Access Compliance Report

Public Rights-of-Way

(Curb Ramps)

Intersection ID: N/A	Main Street: BEREWICK COMMONS PKY	Cross Street: LANGWELL LN	Location: W
ADA ID: 1D999BF63442	Ramp Type: Perp	Initial Pass/Fail: Fail	Overall Compliance: No
Severity Score: 33.75			
Codes/Mitigation Info/Possible Solution		Field Measurements/Component Compliance

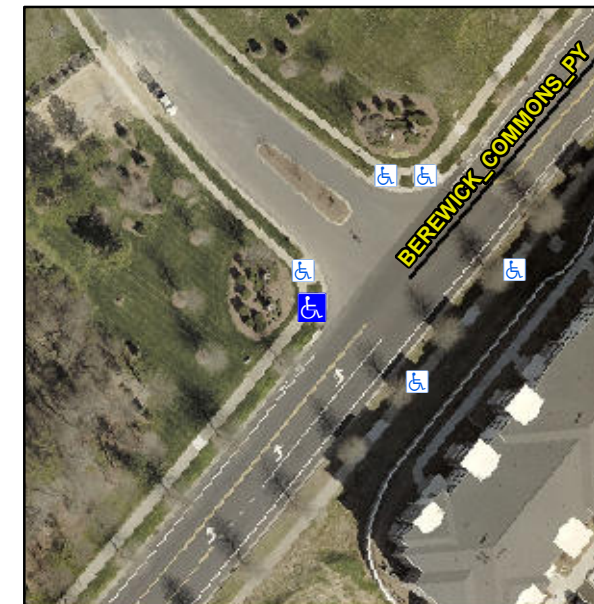
R304.5.1, R304.2.2, R304.5.3

Compliance	Description	Data	Compliance	Description	Data
N/A	Ramp Length (in)	81.0	No	Ramp Slope (%)	9.7
No	Ramp Width (in)	41.0	No	Ramp XSlope (%)	6.2
N/A	Flare Type LT	N/A	N/A	Flare Type RT	N/A
N/A	Flare Slope LT (%)	N/A	N/A	Flare Slope RT (%)	N/A
N/A	Flare Traversable LT?	N/A	N/A	Flare Traversable RT?	N/A
N/A	Landing Length (in)	N/A	N/A	DWS Provided?	N/A
N/A	Landing Width (in)	N/A	N/A	DWS Contrast?	N/A
N/A	Landing Slope (%)	N/A	N/A	DWS Length (in)	N/A
N/A	Landing X Slope (%)	N/A	N/A	DWS Full Width?	N/A
N/A	Landing Curb? (Y/N)	N/A	N/A	DWS Offset (in)	N/A
N/A	Shared Landing?	N/A			
N/A	Gutter Ponding?	N/A	N/A	Gutter Slope (%)	N/A
N/A	Gutter Lip Ht (in)	N/A	N/A	Gutter X Slope (%)	N/A
N/A	Painted X Walk1?	No	N/A	Painted X Walk2?	N/A
	X Walk 1 Direction	To SE		X Walk 2 Direction	N/A
N/A	X Walk 1 Width (in)	N/A	N/A	X Walk 2 Width (in)	N/A
	X Walk 1 Slope (%)	3.5		X Walk 2 Slope (%)	N/A
	X Walk 1 X Slope (%)	4.4		X Walk 2 X Slope (%)	N/A

Remove & Replace Entire Ramp.
